ACCESSION NBR: 8106230397 DOC. DATE: 81/06/11 NOTARIZED: NO DOCKET # 05000335.
 FACIL: 50-335 St. Lucie Plant, Unit 1, Florida Power & Light Co.
 AUTH. NAME: UHRIG, R.E. AUTHOR AFFILIATION: Florida Power & Light Co.
 RECIP. NAME: CLARK, R.A. RECIPIENT AFFILIATION: Operating Reactors Branch 3

SUBJECT: Forwards response to NRC 810526 ltr re asymmetric steam generator transient protection trip function. Two oversized drawings encl. Aperture cards will be in PDR.

Re: St. Lucie Unit 1
Docket No. 50-335
Stretch Power Application

Enclosed is our response to the information request of your letter dated May 26, 1981, regarding the Asymmetric Steam Generator Transient Protection Trip Function.

Figure 10
 REACTOR PROTECTIVE SYSTEM INTERFACE LOGIC DIAGRAM

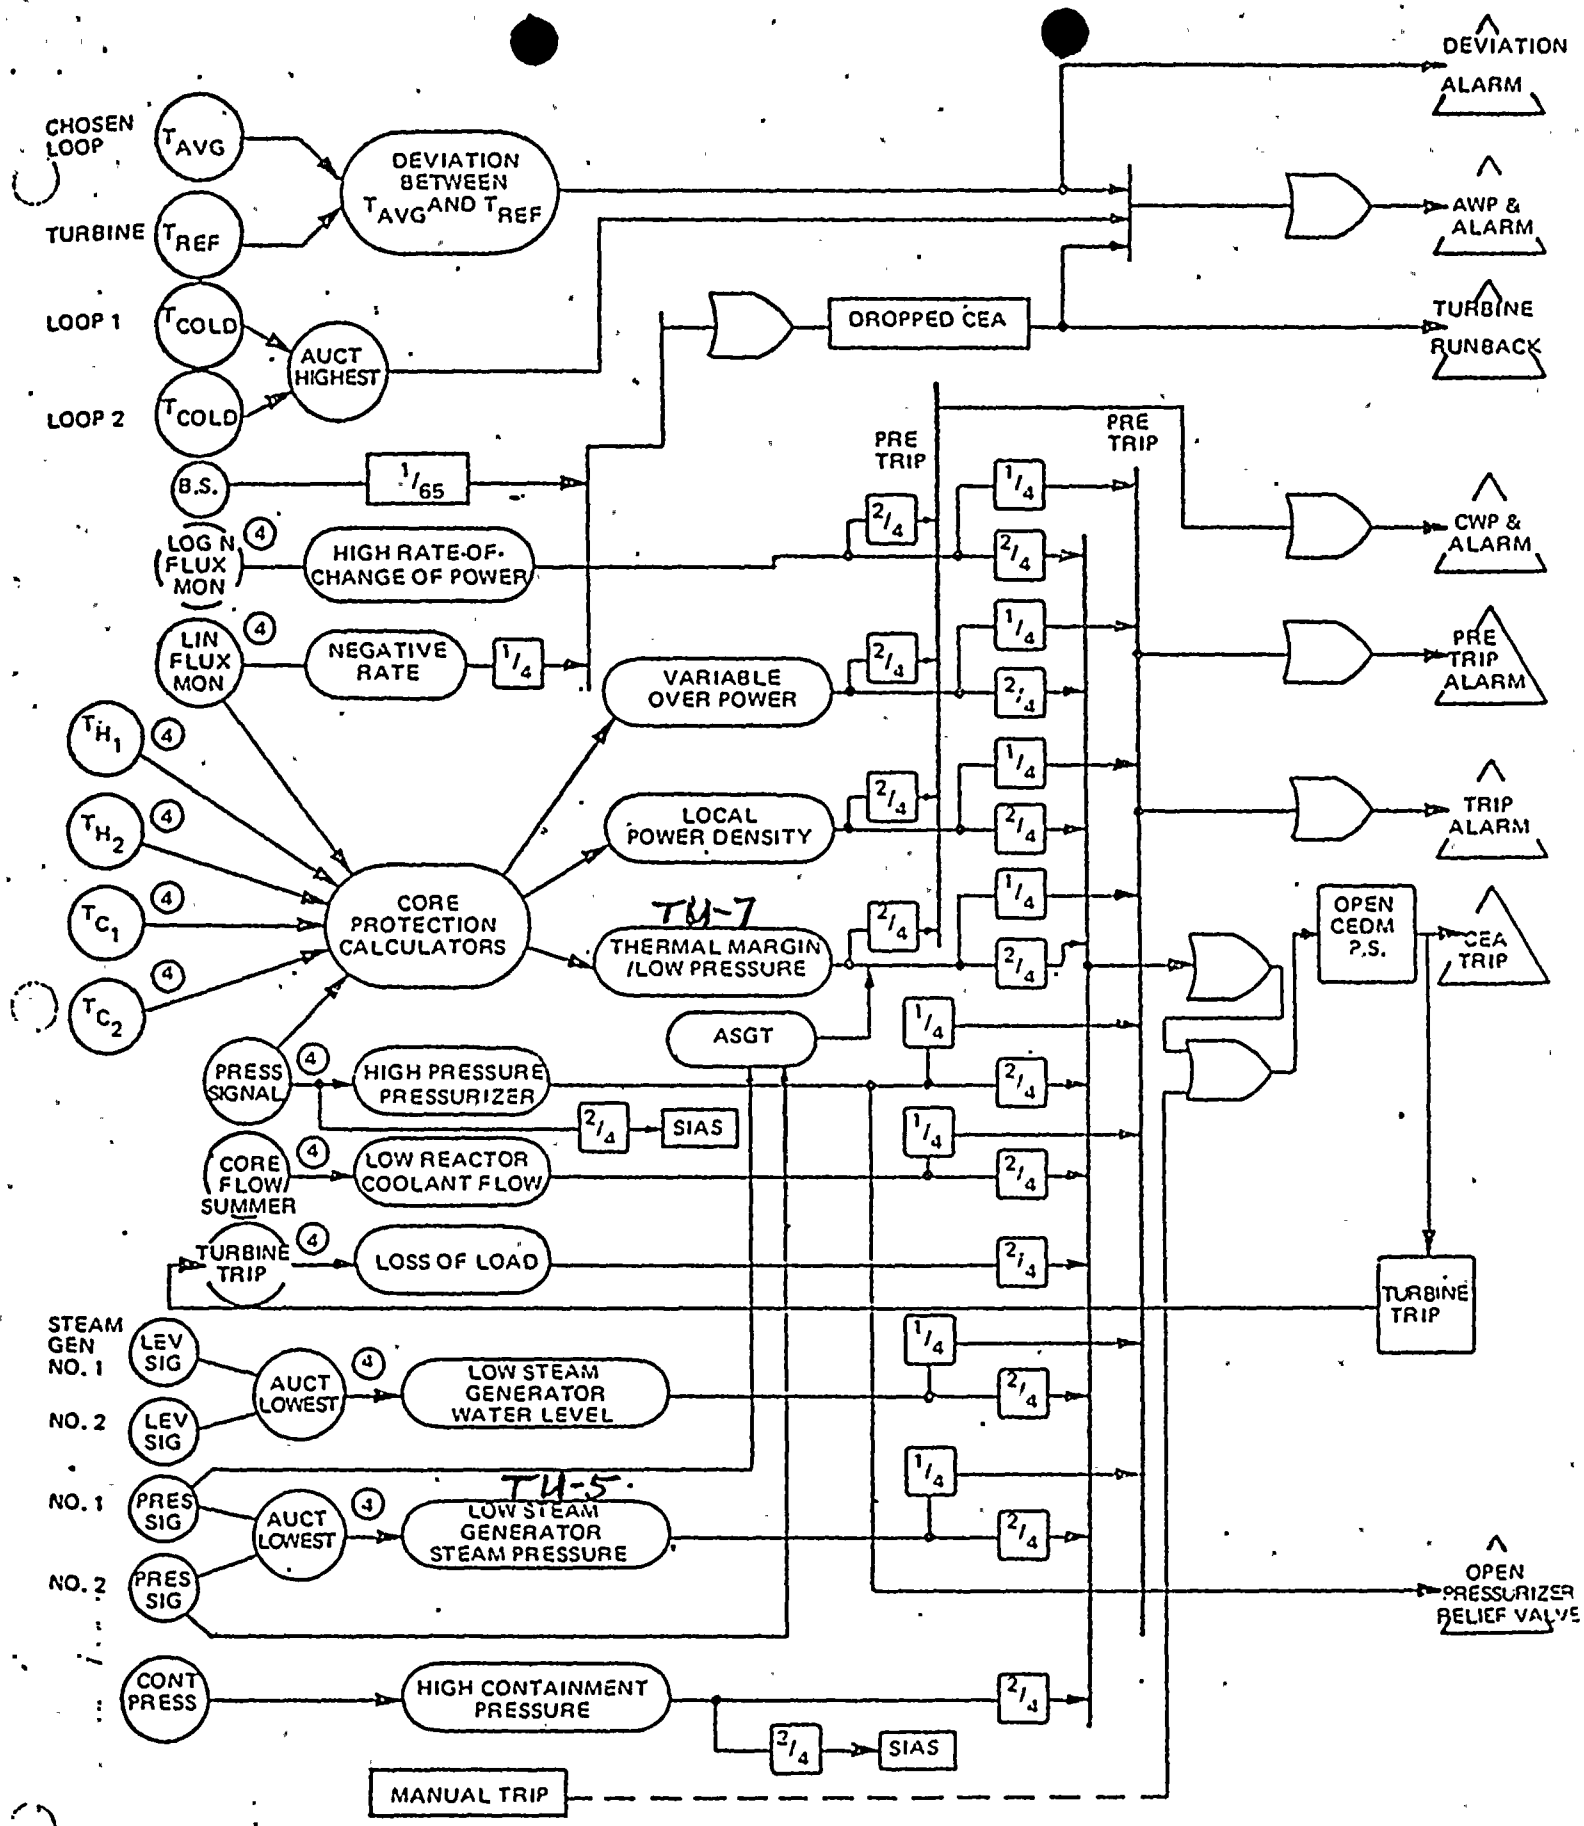
- Provide TM/LP Trip Calculator electrical schematics showing the added ASGTPTF. (one channel).

- Fig 10., RPS interface logic diagram, illustrates how the SG pressure signals already available to the RPS (Low SG Pressure Trip Unit 5) are monitored in the Core Protection Calculator to force a Thermal margin/ Low Pressure trip when the difference in SG Pressures exceeds predetermined limits (Trip Unit 7). Figures 34 and 43 show the above function in block diagram form in more detail. E-19367-411-071 and E-19367-411-302 are the signal and CPC schematics.

Figure 43
ASGT TRIP

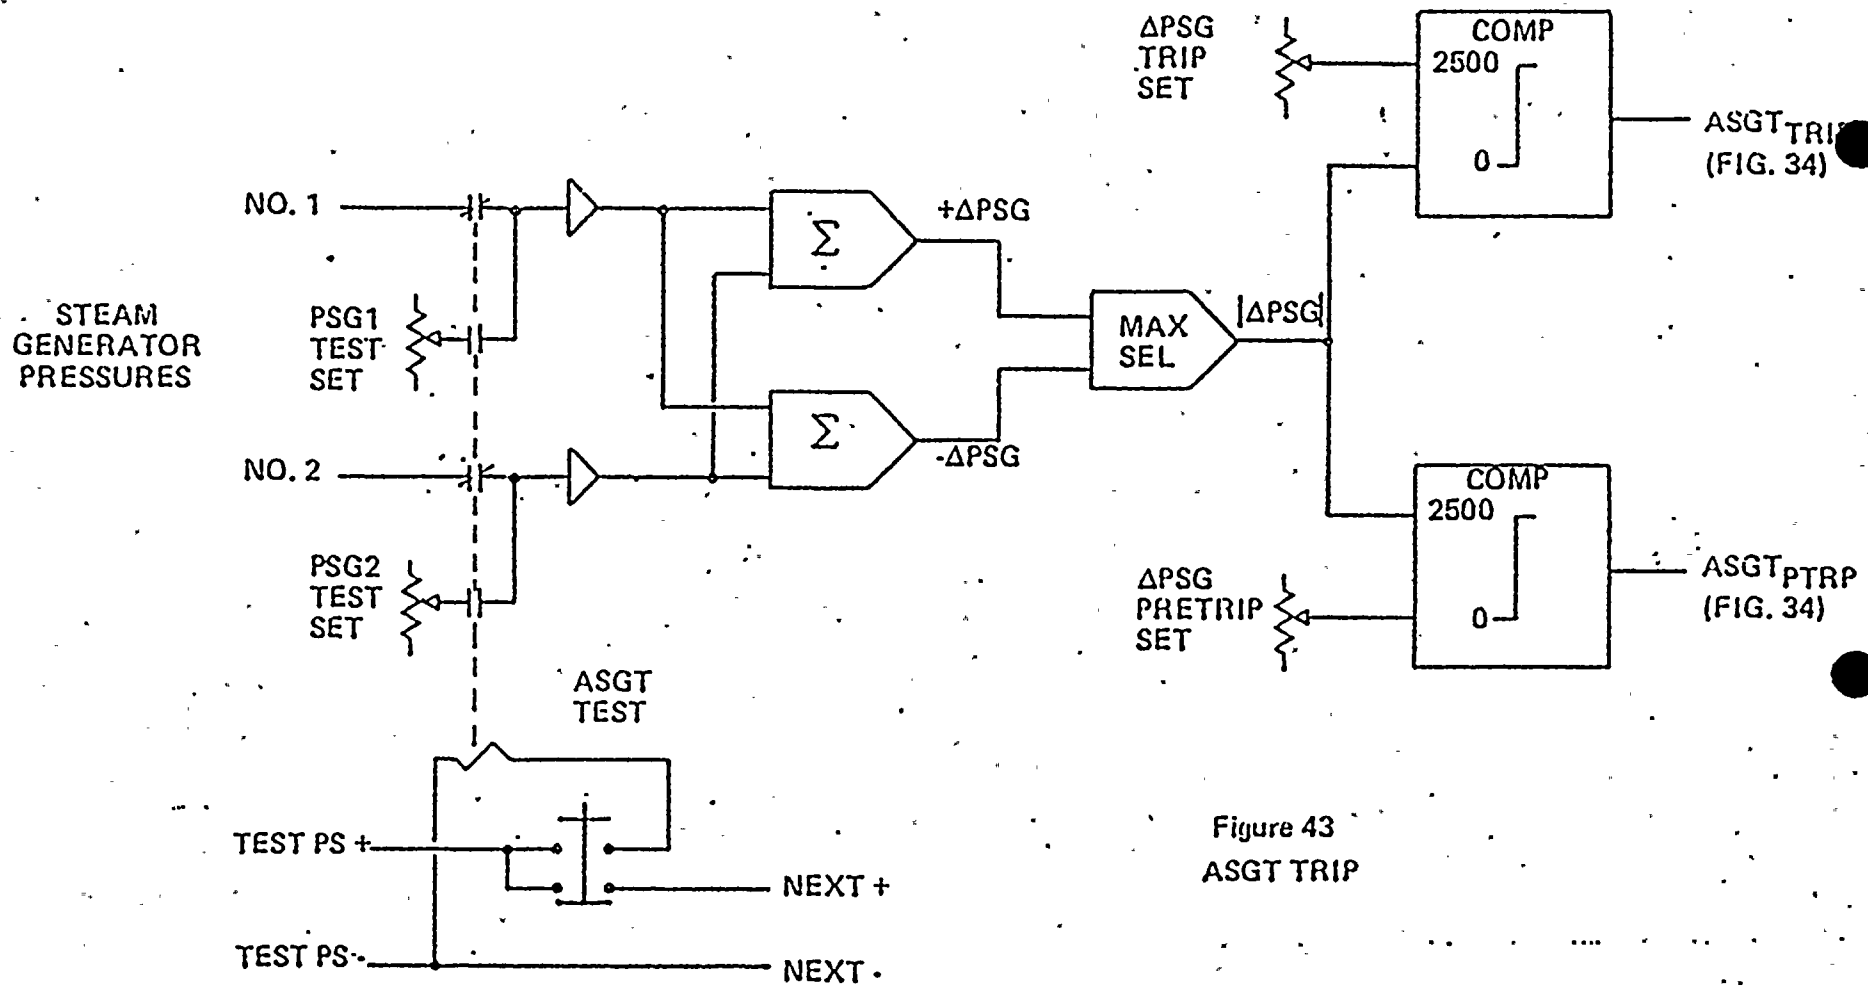
Describe the tests(channel checks, functional test, etc.) planned to assure operability of the ASGTPTF channels.

The ASGTPTF test circuit, as shown on Figure 43, is contained in the Core Protection Calculator (CPC-2). This test circuit consists of a test switch, which connects locally generated test signals (in place of the actual pressure signals) to the ASGT differential comparator circuit, and potentiometers to vary those simulated signals and verify ASGT circuit operation. Setpoints and signals are monitored with the built-in digital voltmeter located in the RPS Calibration drawer.

The test consists of first bypassing the TM/LP Trip Unit 7 in the channel under test.

The second step is to verify that the trip and pretrip voltages are accurate with the DVM. Adjustments are made if the voltages are not as desired.

The third step is to fix the simulated signal for SG #1 Pressure at some nominal value.

The fourth step is to press the test push button (located on the inner surface of the CPC-2 front door) and vary the simulated signal for SG #2 Pressure above and below that for SG #1 Pressure to verify that Trip Unit #7 trips at the required differential simulated pressure, and provides pretrip indication at the prescribed pressures.

The fifth step is to hold SG #2 Pressure signal at a fixed value and vary SG #1 signal above and below that for SG #2 as for step 4. This again verifies trip and pretrip of trip Unit 7 at the proper values.

Next, the Test Push Button is released to remove the test signal and restore the process loop trip inputs. Then the unit is removed from bypass. The above test is repeated for each of the four RPS channels.
